SR-2 – ADVISORY STAFF REPORT (03-06-2026)

ADDRESS: 892 W BOSTON BOULEVARD (EDWARD FISHER RESIDENCE)

APPLICATION NUMBER: HDC2026-00039

SCOPE: INSTALL POOL, LANDSCAPING

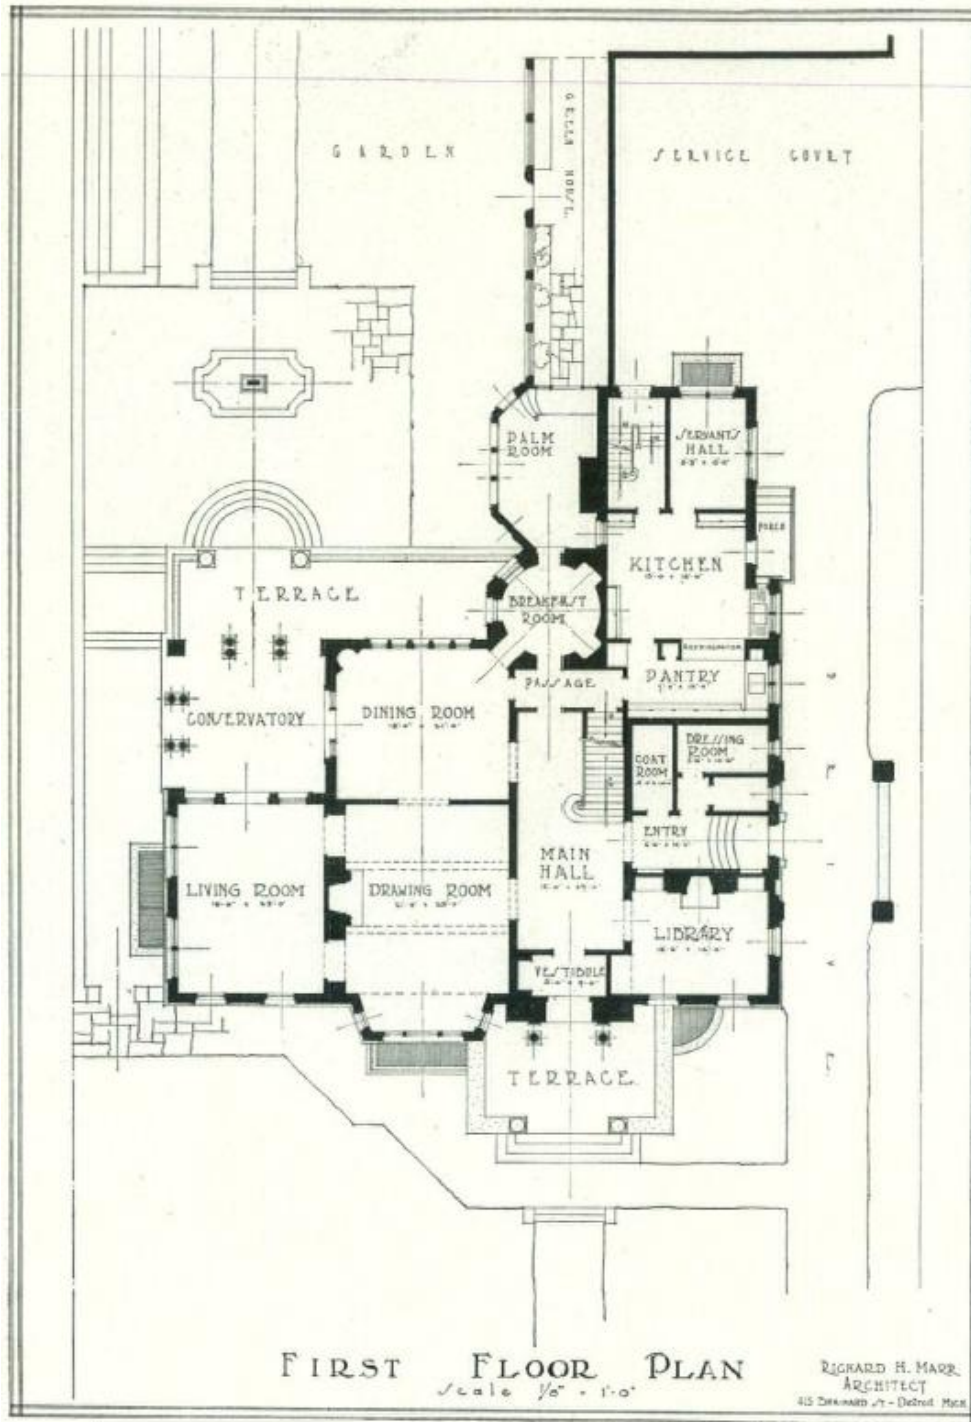
Rear of the house (north end), terrace, and south water feature. The round arches to the sheltered porch just outside the conservatory remain as shown, but doors have been installed between them to enclose the porch. The limestone fountain has been replaced by a more decorative fountain with a sculpture and bowl on a base, but the simpler limestone fountain shown here is proposed to be replicated and reinstalled. The limestone terrace and steps remain, and the pavers have been replaced with pavers. (The Architectural Record, February 1926)

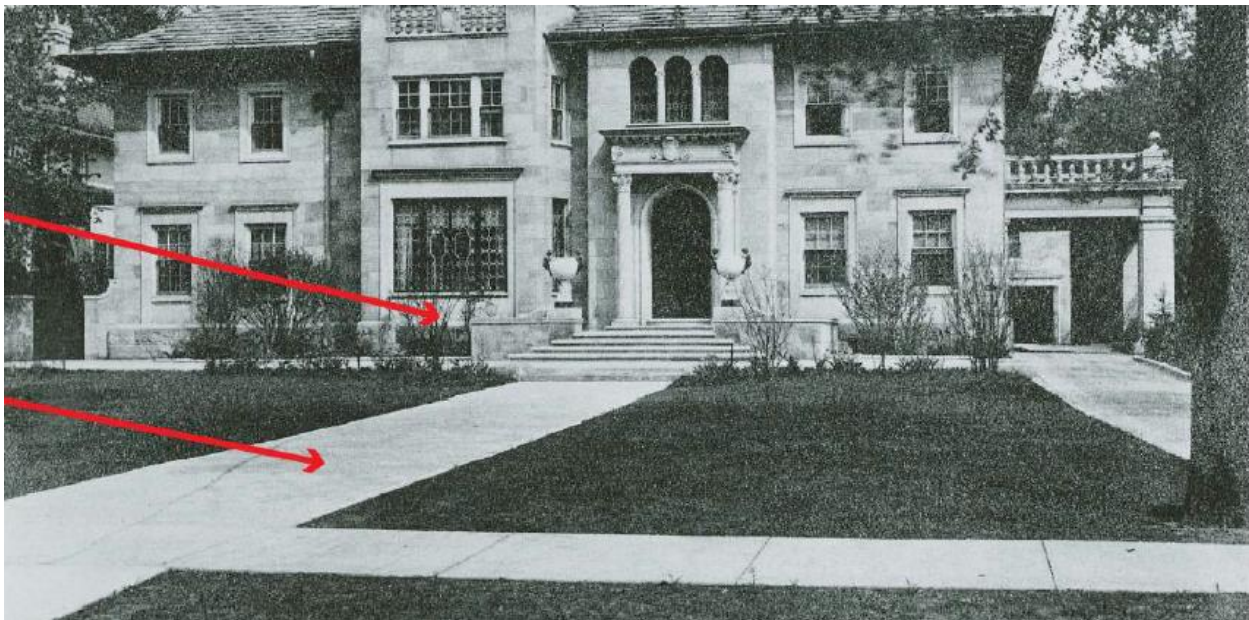
From applicant's materials. The existing dyed concrete and paver combination is shown on left. In the historic photo to the right, the entry walk looks like concrete, similar to the public sidewalk, but it is difficult to discern the material with certainty. The drive was brick in historic photos.

Detail of historic photo above. The front entry walk appears to have a long crack in it down through the sidewalk, which indicates to staff that it was concrete or stone and not brick pavers like the drive.

- **Staff Response:** Staff finds that the proposed concrete installation on the front entry walk is a restoration of a missing feature, meeting the Secretary of the Interior's Standards and Guidelines for Rehabilitating Historic Buildings.
- **Replace front yard lanterns on poles**
 - **Proposed:** Remove existing gas lanterns (installation date unknown)

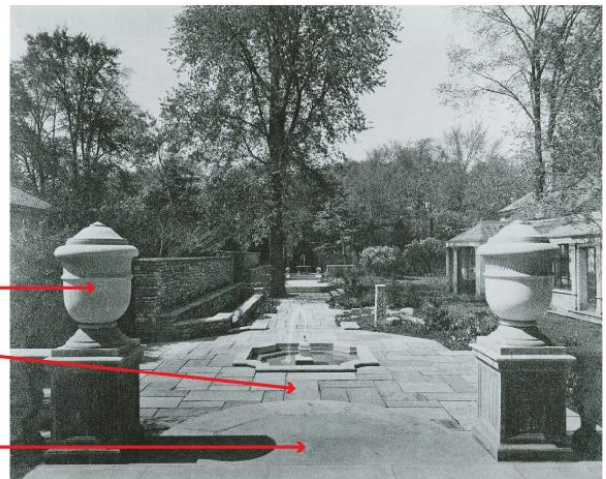
Photos from application materials. Current photo on left and historic photo on right. These views show some of the most important, character-defining elements in this rear yard designed by Fleming, including the terrace and pedestals (still intact), shallow fountain in an octagon border, pavers around the octagon (replacement pavers), west wall, and continued axial path with pavers to north water feature.

Staff response: Staff finds that the terraces with pavers, from the upper terrace to the north water feature and framed by trees, are central design elements in this work by significant and nationally renowned landscape architect Bryant Fleming. Large pavers were planned and installed, and they have since been replaced with smaller pavers and bricks; still, staff finds that the historic, character-defining elements remain and should be preserved. If the existing pavers and bricks are beyond repair, the pavers should be replaced in kind or, more faithful to the Guidelines, restored to their former appearance. Staff does not assess that changing the pavers to exposed aggregate concrete with limestone bands as shown in the sample above meets the Standards. Staff does not find that the proposed matches the existing in size, scale, color, texture, or materials.

Proposed pool products, from applicant materials.

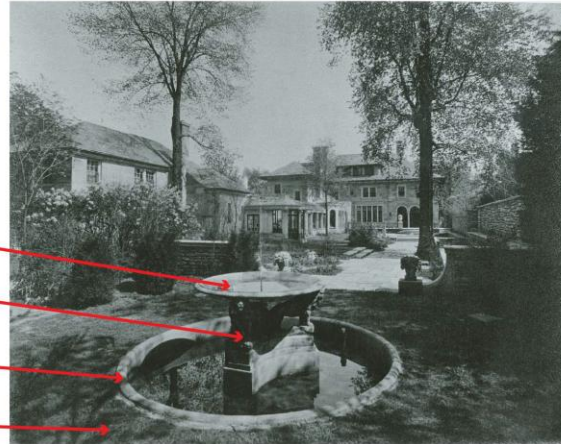
- **Staff response:** Staff finds that the terraces and axial path paved with geometric pavers, along with the west wall of uncut stones, are all significant, historic, character-defining features of this designed landscape and that the landscape features tie the Italian Renaissance house to its site. Mr. Fleming’s use of shrubs and trees, water features, walls, and pavers in formal, geometric ways organize this lot and integrate the yard with the Italian Renaissance house and its architectural details.

- Removing the pavers on this terrace, widening it, and replacing the pavers with concrete and a modern swimming pool would interrupt the axial path the landscape architect designed, and would significantly depart from his plan and diminish the formality and intention of the plan. The result would be the alteration of features and spaces that characterize this property. Consequently, it is staff’s opinion that the modern addition of a swimming pool in the proposed location conflicts with Standards 2, 5, and 6 in this case. Further, the proposed replacement of materials with exposed aggregate concrete would not uphold Elements of Design 7, 8, 10, and 14.

Rear yard, north water feature/fountain with lions base

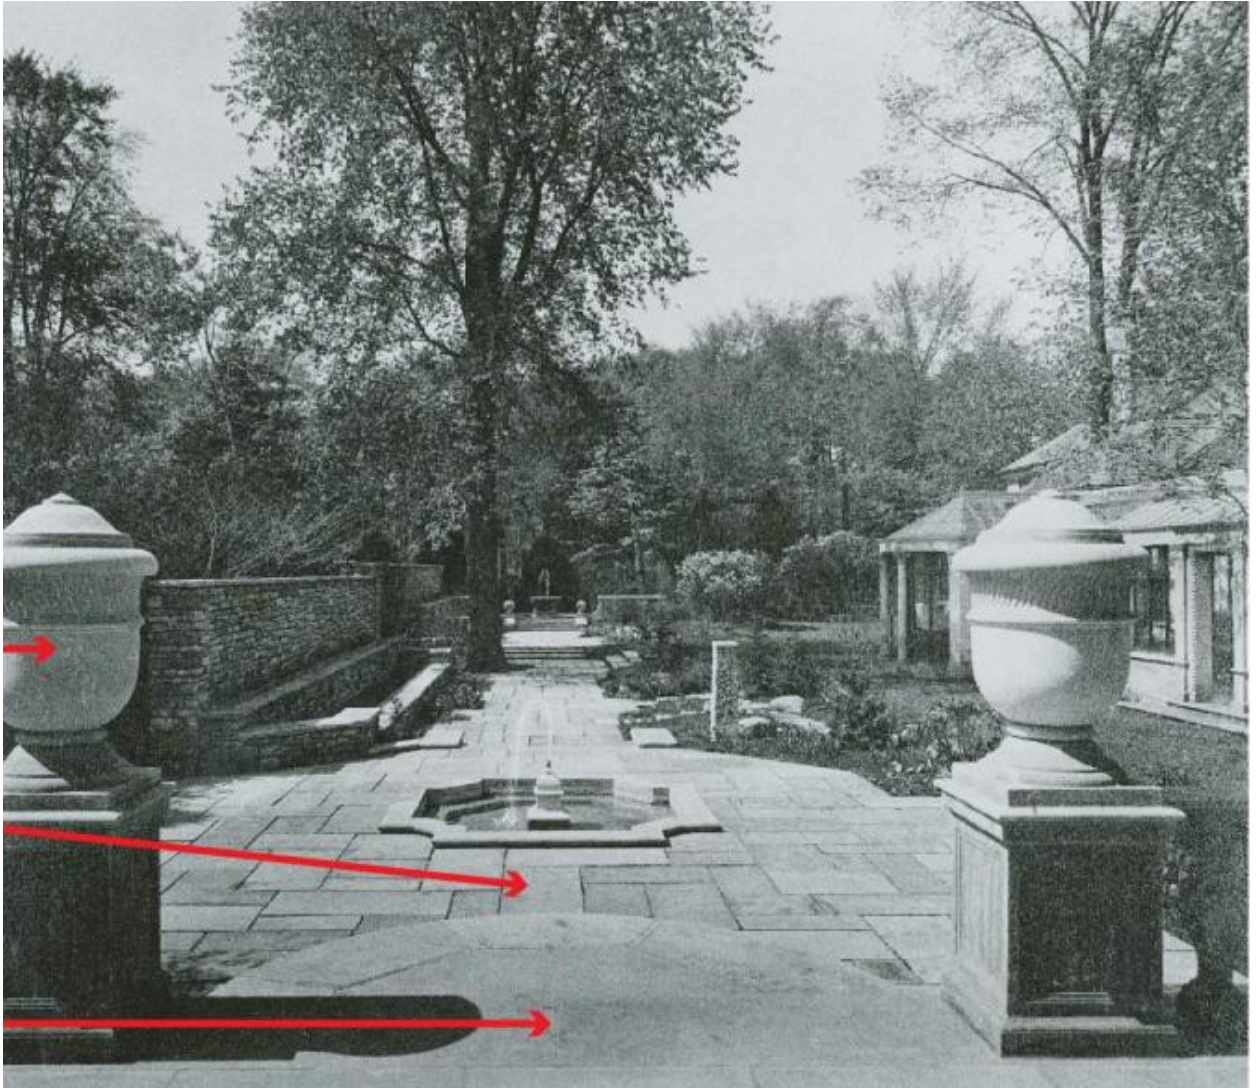
The bowl only (no pedestal) is proposed to replace the current broken bowl on top of the lions base. Then, the plan is to restore the fountain to working order.

- **Staff response:** Restoration of both water features is important to Mr. Fleming’s vision for the space and the design he implemented. The original bowl was shallower and simpler.

5. Final designs will be submitted to staff for review and approval for the replication of the stone south water feature and for the restoration of the north fountain with the lions base.
6. A detailed landscape inventory conducted by a landscape architect or arborist will be submitted to staff that assesses whether any existing tree or shrub installations are part of the original landscape design. Such original and character-defining design features, where present, must be retained or preserved to maintain the property's historic character.
